## PLANNING TECHNICAL REVIEW COMMITTEE –AGENDA

**RE: Site Plan Review Application  
Technical Review Committee Response Letter  
383 Sixth Street, Dover, NH  
Tax Map D, Lot 16F  
JBE Project No. 15002**

## TECHNICAL REVIEW COMMITTEE MINUTES - P15-12

DRAWING No.  
**C2**  
 SHEET 3 OF 17  
 JBE PROJECT NO. 15002

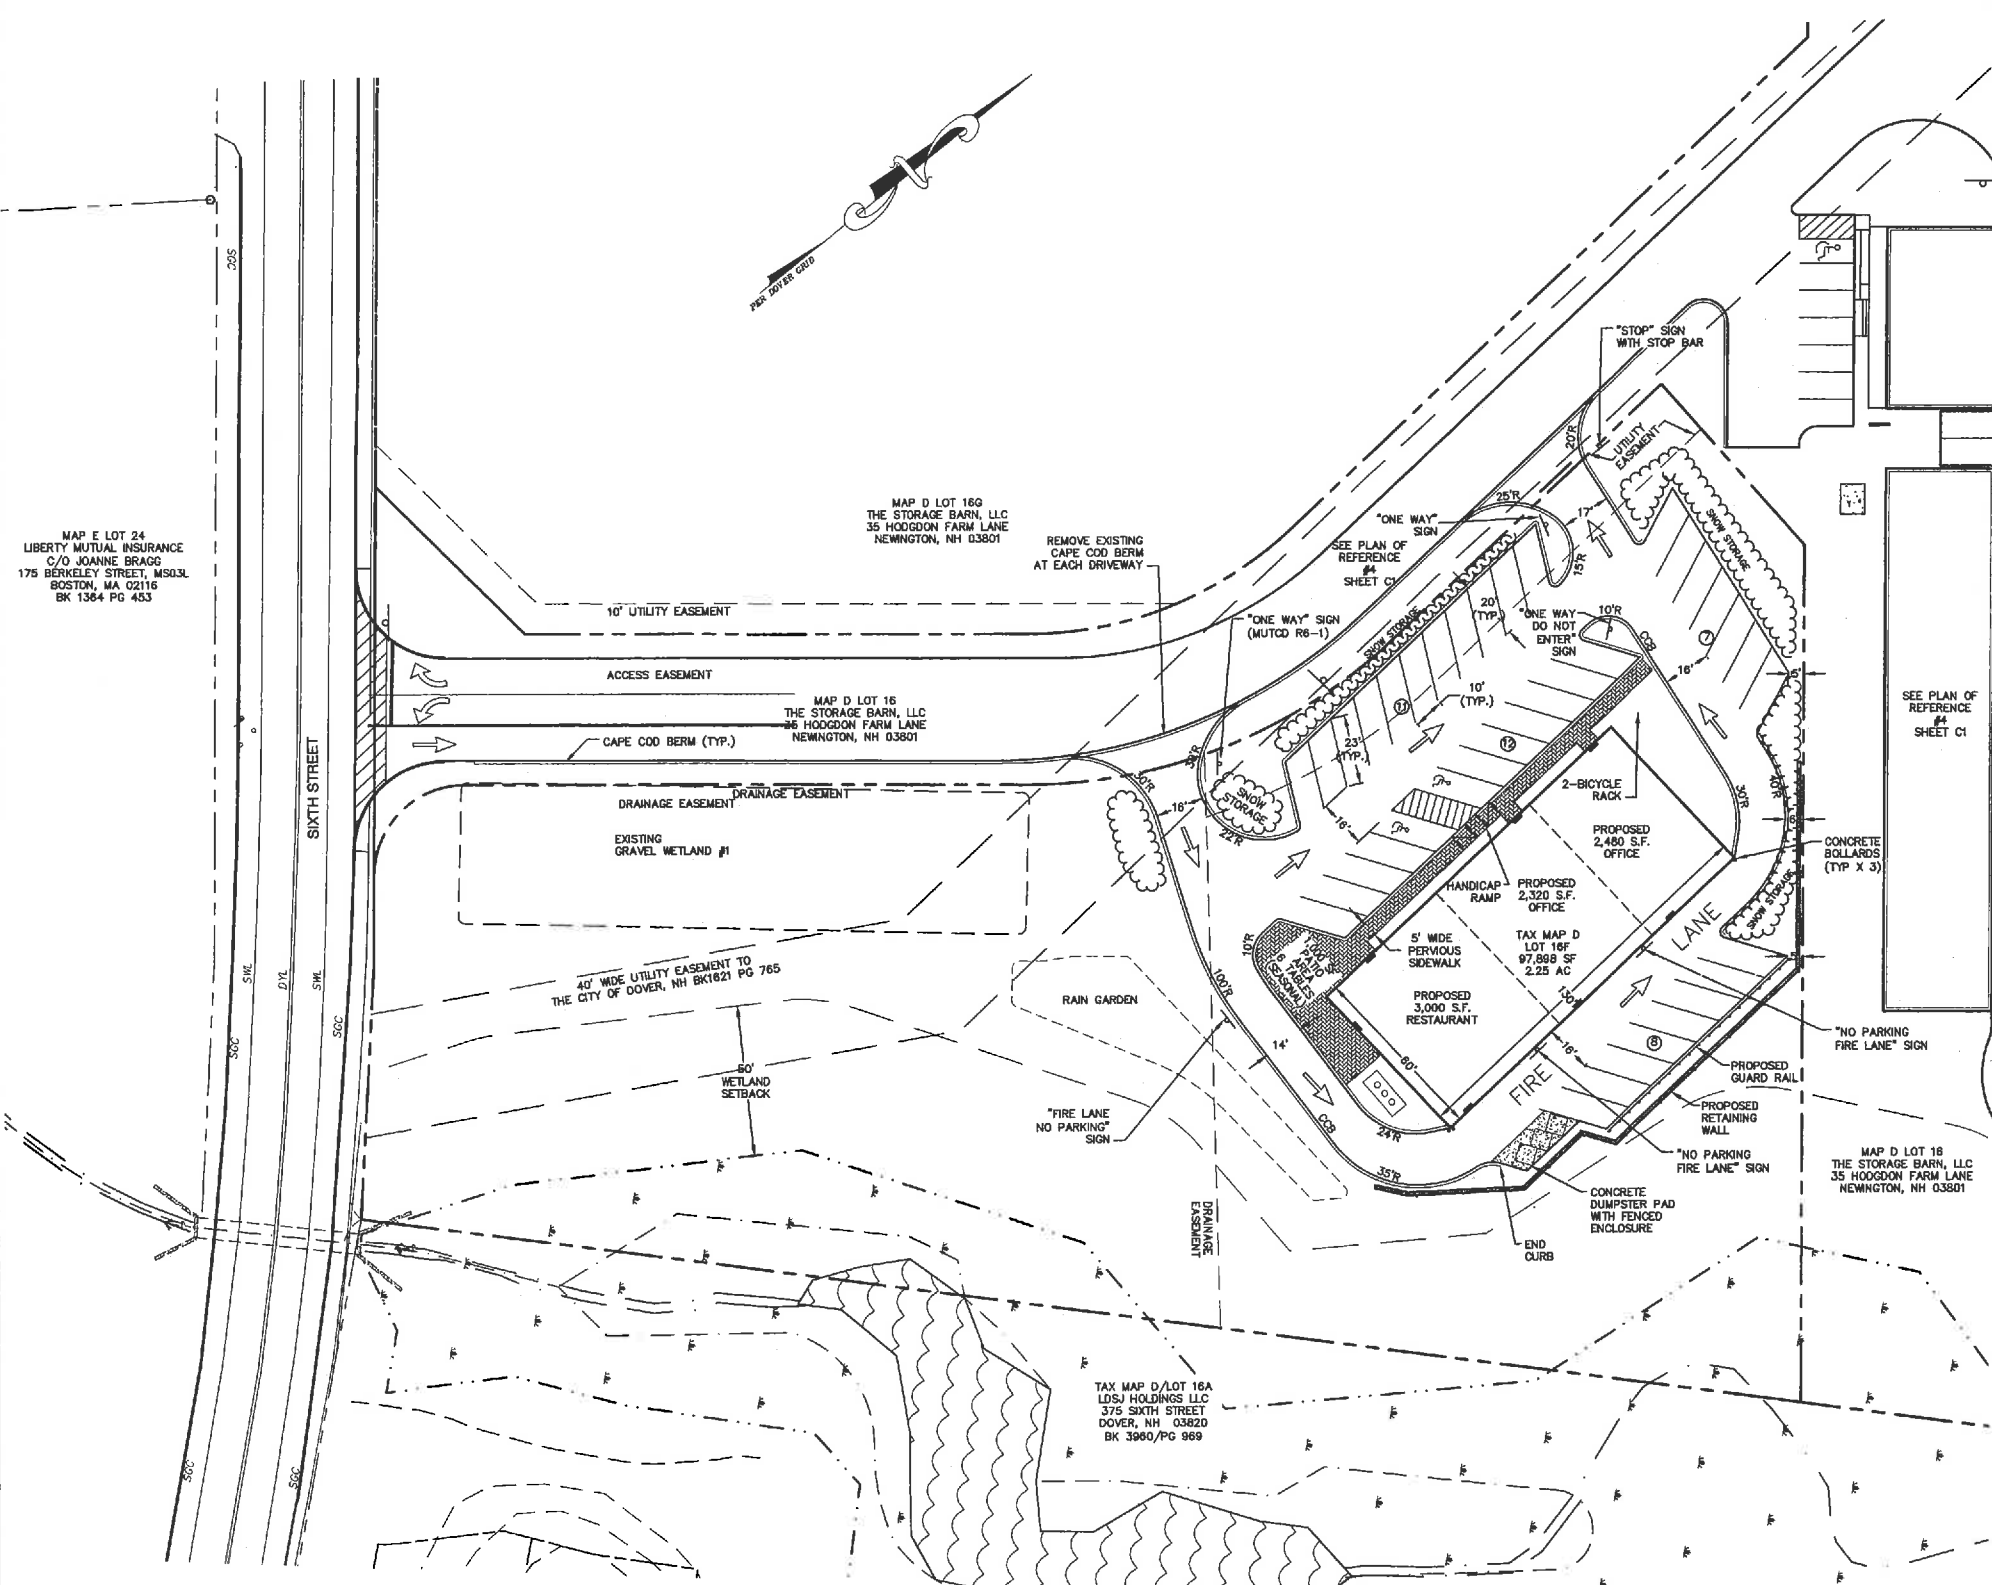
- Add north arrow  
**RESPONSE: Done.**
- Remove proposed snow storage areas within right-of-way and adjacent lot or provide easement  
**RESPONSE: Snow has been revised and kept on-site. See also Note 14 on Sheet C2.**
- Show fire lane  
**RESPONSE: Done.**
- Site Notes 2 and 23: specify dimensional requirements approved by TDR  
**RESPONSE: Done in Note 2. Note 23 has been deleted.**
- Site Note 3: clarify that the 25 restaurant seats are for inside or out (no parking requirements for outside seating)  
**RESPONSE: Done.**
- Consider shared parking options with the Storage Barn use  
**RESPONSE: Not possible, as needed for Storage Barn.**
- Site Note 3: correct required parking spaces to 34  
**RESPONSE: Done.**

- Site Note 4: adjust spacing  
**RESPONSE: Done.**
- Site Note 10: revise to read “All traffic signage and pavement markings...”  
**RESPONSE: Done.**
- Add Common Site Plan Notes 17, 18, 19, 20 (see attached)  
**RESPONSE: Done.**
- Add note that property is subject to conditions of approval set forth in Z14-04  
**RESPONSE: Done.**

- Add north arrow
- Remove proposed snow storage areas within right-of-way and adjacent lot or provide easement
- Show fire lane
- Site Notes 2 and 23: specify dimensional requirements approved by TDR
- Site Note 3: clarify that the 25 restaurant seats are for inside or out (no parking requirements for outside seating)
- Consider shared parking options with the Storage Barn use
- Site Note 3: correct required parking spaces to 34
- Site Note 4: adjust spacing
- Site Note 10: revise to read “All traffic signage and pavement markings...”
- Add Common Site Plan Notes 17, 18, 19, 20 (see attached)
- Add note that property is subject to conditions of approval set forth in Z14-04
